ST13-001

2013 JX; SERVICE KIT FOR STEERING GEAR AND HIGH PRESSURE HOSE REPLACEMENT

APPLIED VEHICLE 2013 JX (L50)
VIN AND DATE: built before 5N1AL0MM(*)DC 304569 and April 12, 2012
TRANSMISSION: AWD (RE0F09B) **Only**

Figure 1

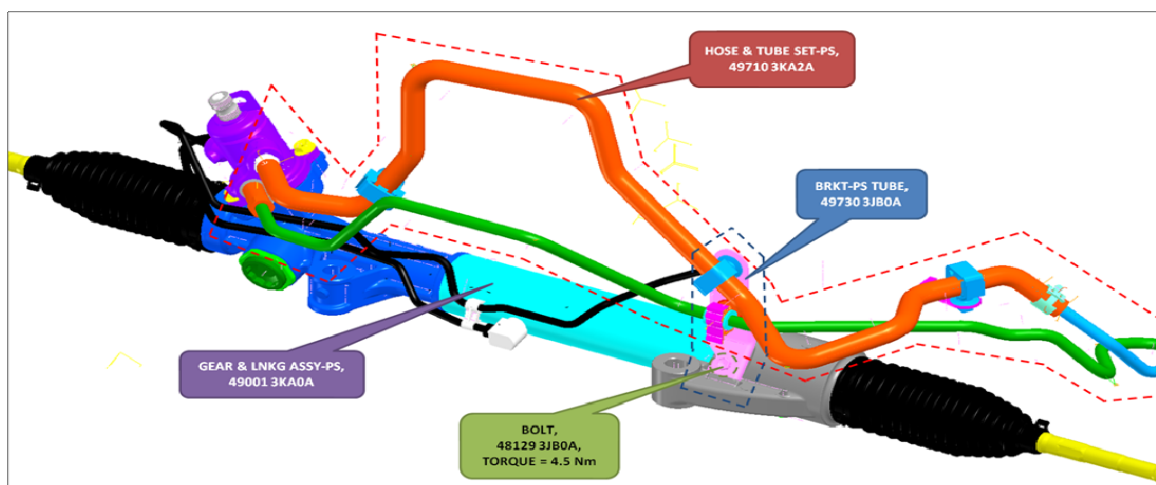
If the Power Steering Hose & Tube or the Power Steering Gear assemblies need to be replaced, please replace them with the service parts listed in the Parts Information below.

- See Fig. 1 for parts illustration.
- Refer to section ST (Steering System) of the applicable Electronic Service Manual (ESM) for the removal and installing instructions.

(1) ALL (3) parts must be replaced AS A SET.

- Replace old "BRKT - PS TUBE & old BOLT" on the Power Steering Gear with the new BRKT & BOLT above.

(1) Must be replaced AS A SET

**Torque new BOLT to 4.5 N·m (0.50 Kg-m, 43 in-lb)
